STATE OF CONNECTICUT  
CONNECTICUT SITING COUNCIL

IN RE: :  
 :  
APPLICATION OF CELLCO PARTNERSHIP : DOCKET NO. 455  
D/B/A VERIZON WIRELESS FOR A :  
CERTIFICATE OF ENVIRONMENTAL :  
COMPATIBILITY AND PUBLIC NEED FOR :  
THE CONSTRUCTION OF A WIRELESS :  
TELECOMMUNICATIONS FACILITY AT 99 :  
EAST STREET, SOUTHLINGTON, :  
CONNECTICUT : FEBRUARY 13, 2015

**RESPONSES OF CELLCO PARTNERSHIP  
D/B/A VERIZON WIRELESS TO CONNECTICUT  
SITING COUNCIL PRE-HEARING INTERROGATORIES, SET ONE**

# **ATTACHMENT 1**

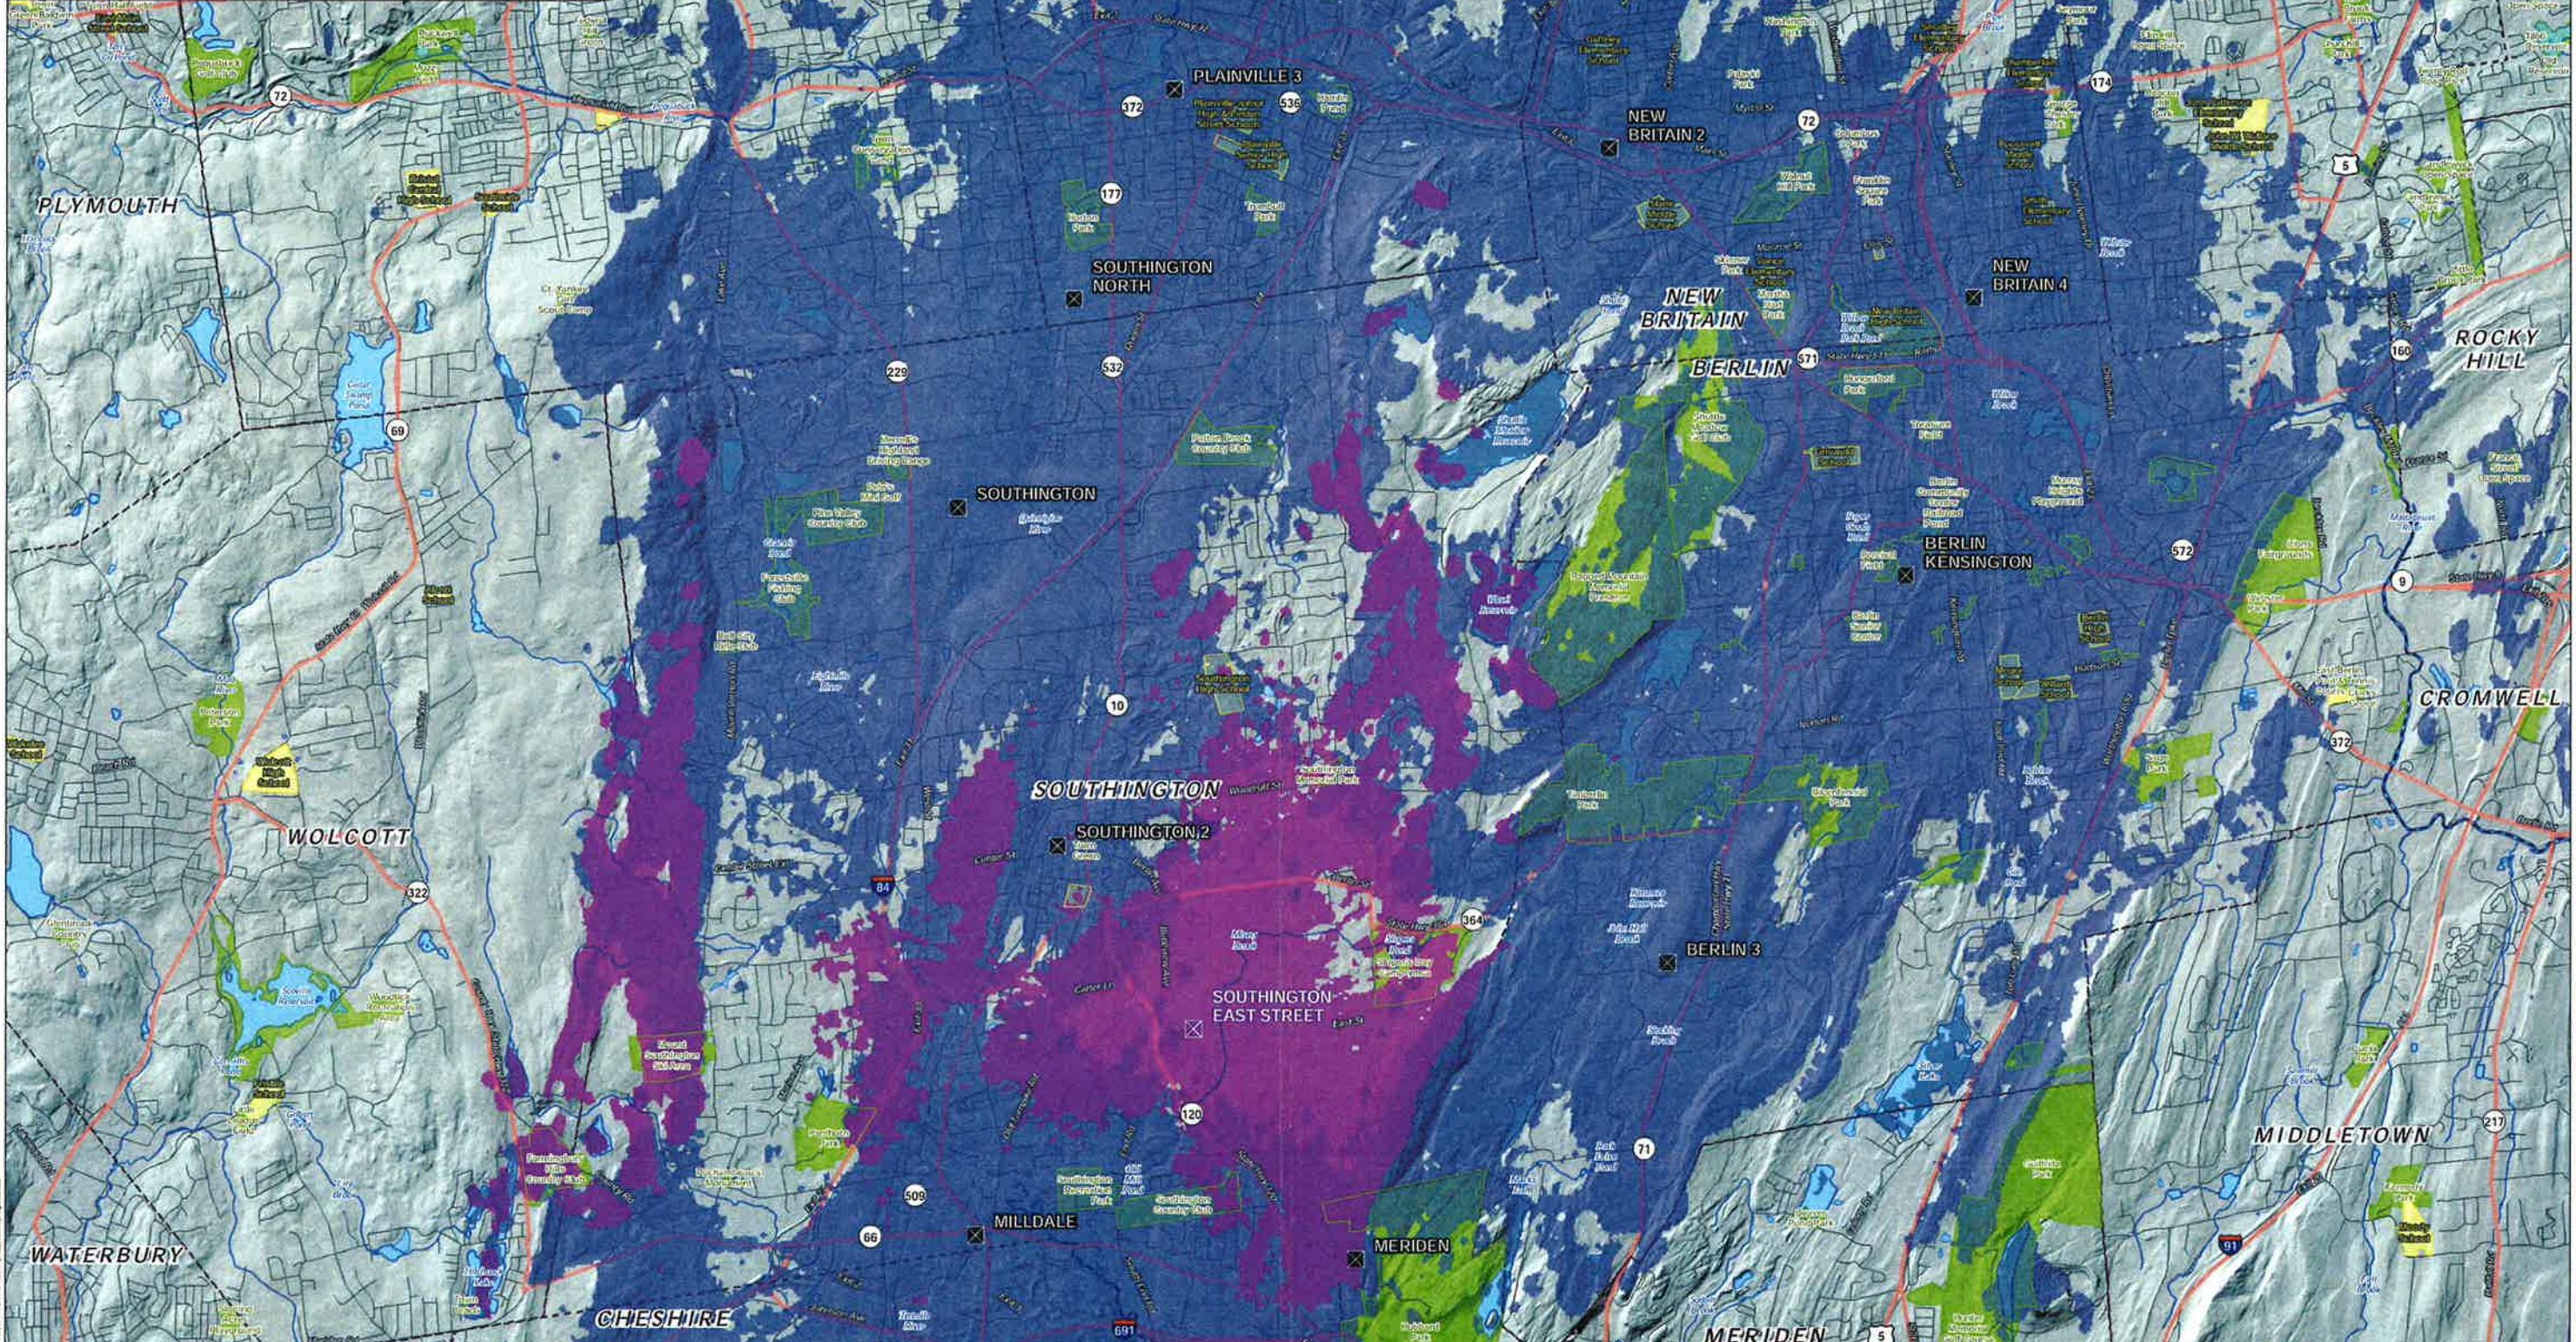
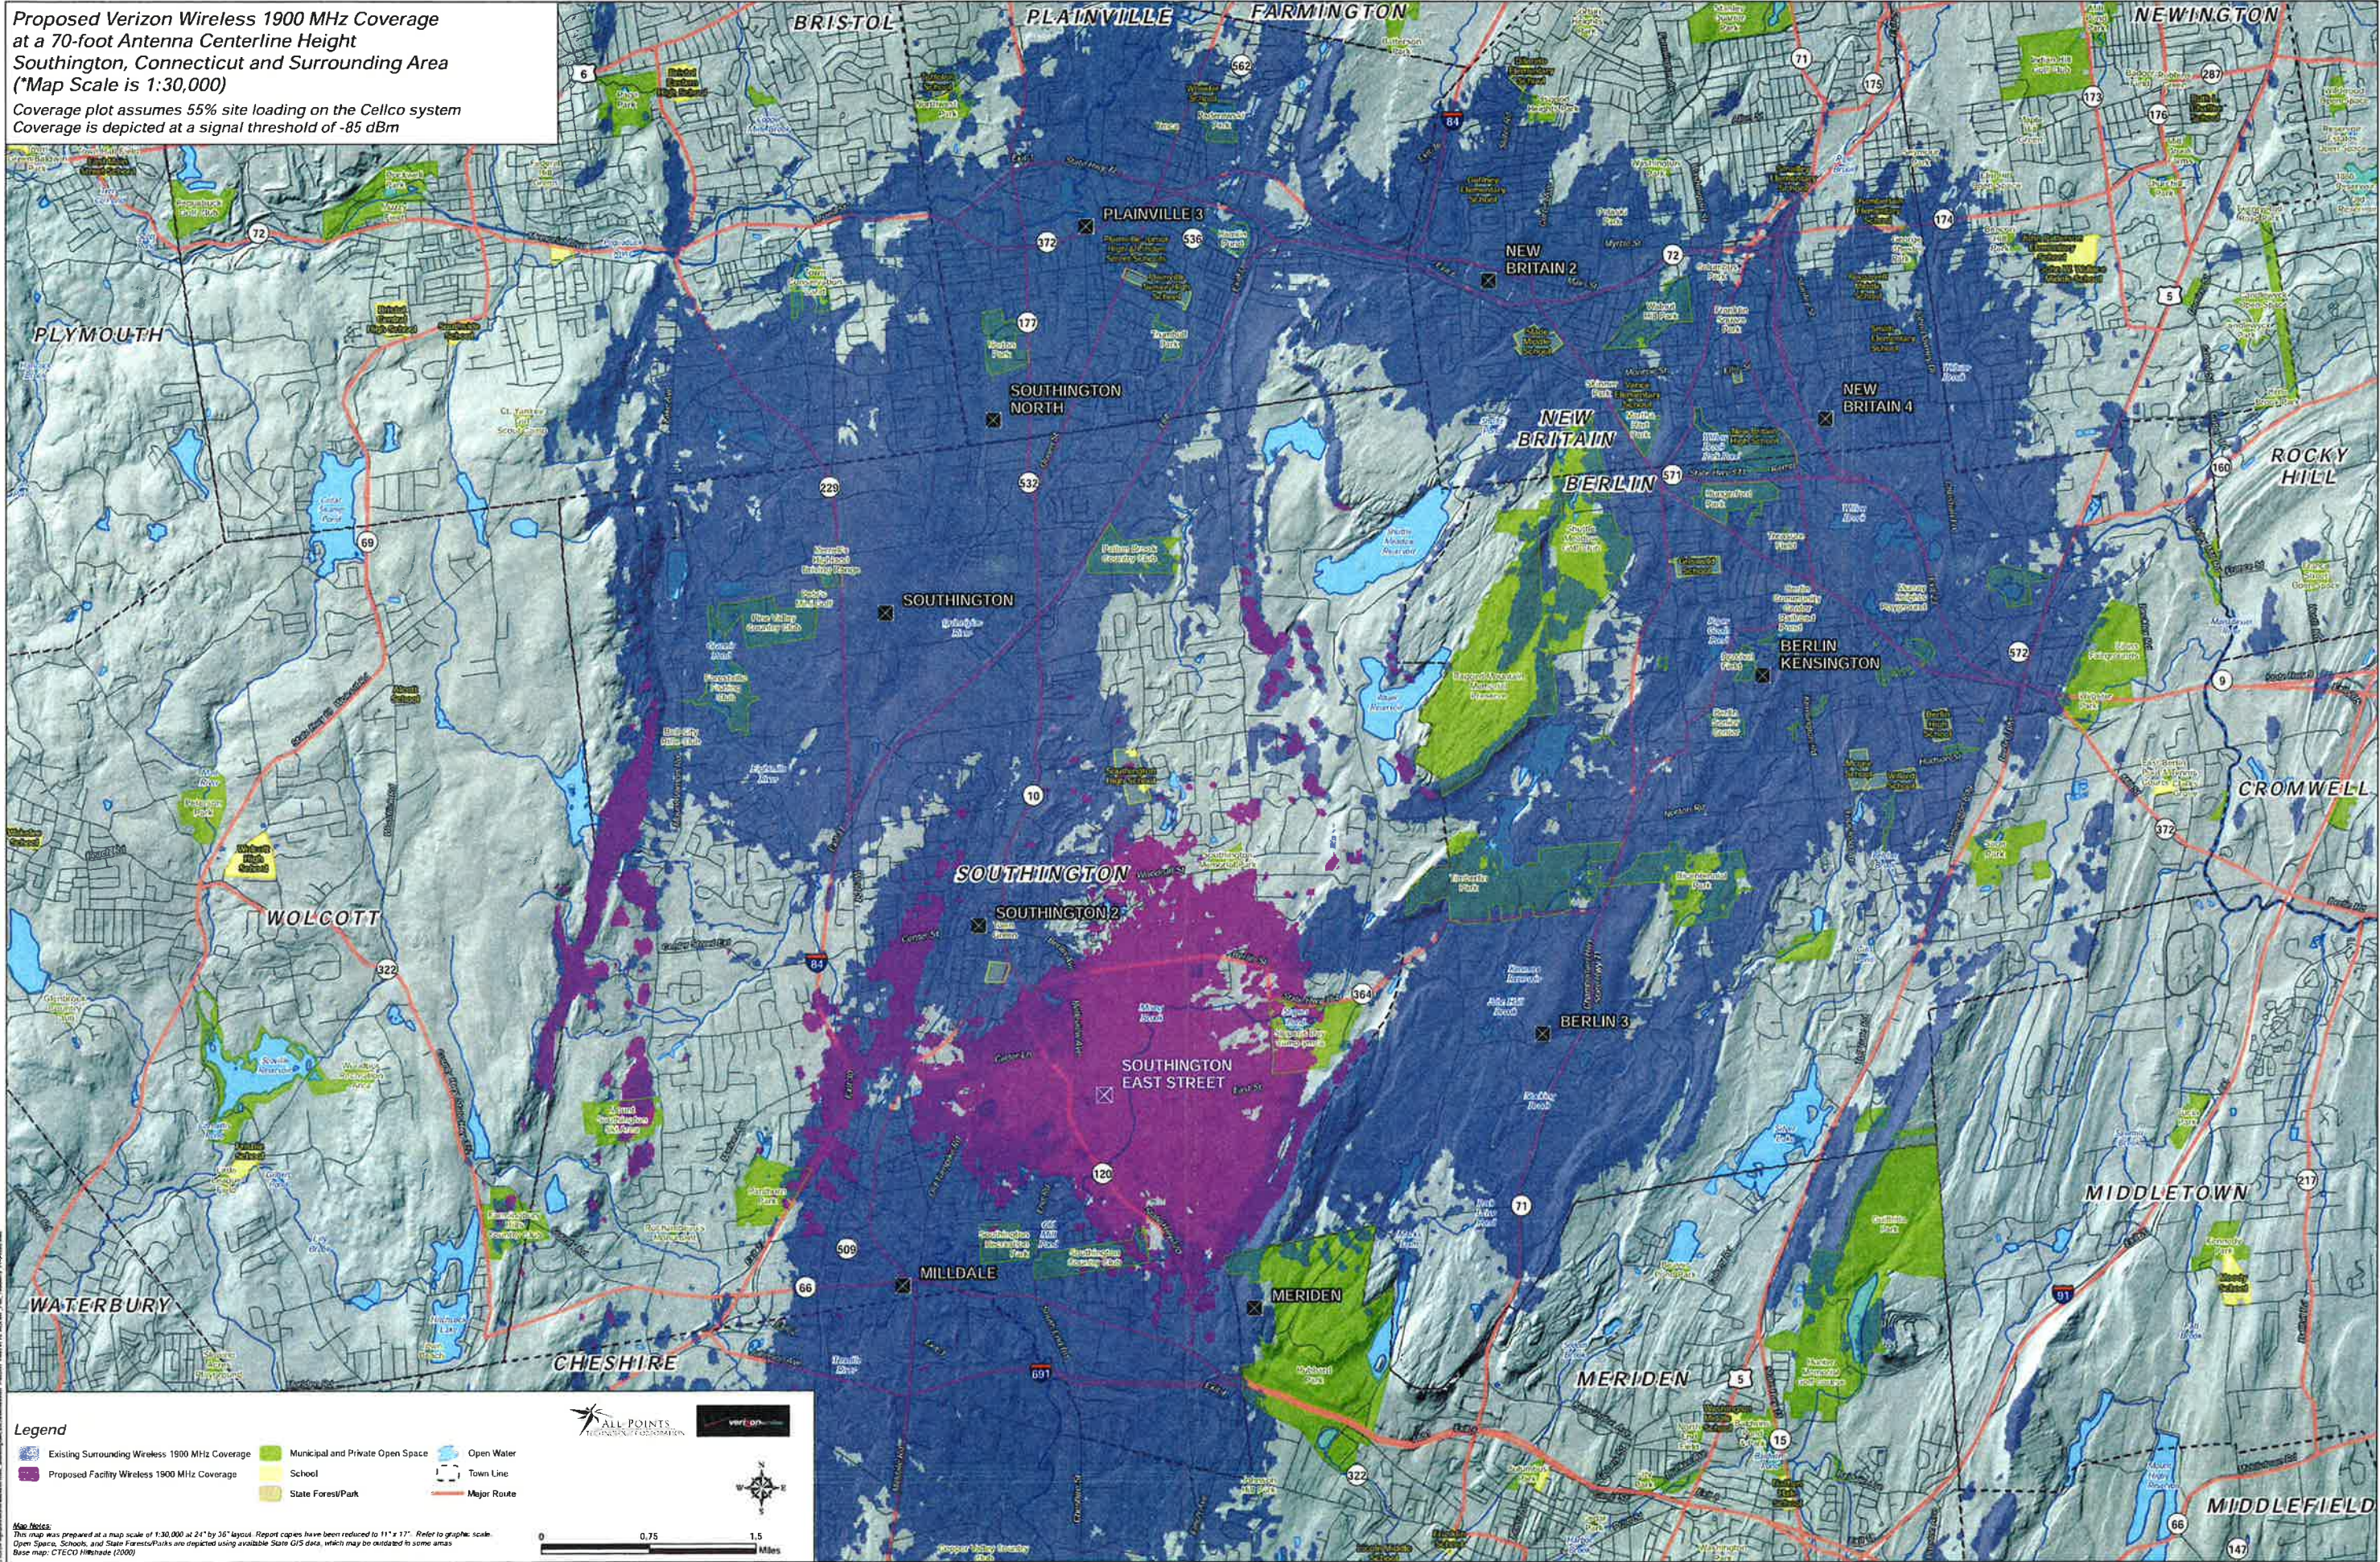
What is the lowest height at which Cellco's antennas could achieve its coverage objectives at the proposed site? What problems would Cellco experience with antennas below this height? Submit propagation maps showing the coverage at ten feet below this height.

After analyzing this location, Cellco's RF Engineers have determined that an 80-foot antenna height is, in fact, the lowest height at which Cellco can satisfy its wireless service objectives. Lowering the antennas to a centerline height of 70 feet above ground level ("AGL") would have a significant impact on coverage from this site, particularly to the north, east and southeast due to its proximity of mature trees (some between 70 and 80 feet tall) that surround the cell site and the larger Town-owned parcel, generally. At 70 feet AGL, the coverage footprint from the site would shrink from 11.92 square miles (at 80 feet AGL) to 10.86 square miles at 700 MHz frequencies; 13.3 square miles (at 80 feet AGL) to 12.40 square miles at 850 MHz frequencies; 7.3 square miles (at 80 feet AGL) to 6.78 square miles at 1900 MHz frequencies; and 5.63 square miles (at 80 feet AGL) to 5.14 square miles at 2100 MHz frequencies. Plots showing Cellco's wireless service at an antenna height of 70 feet AGL are included in Attachment 1 of these responses.
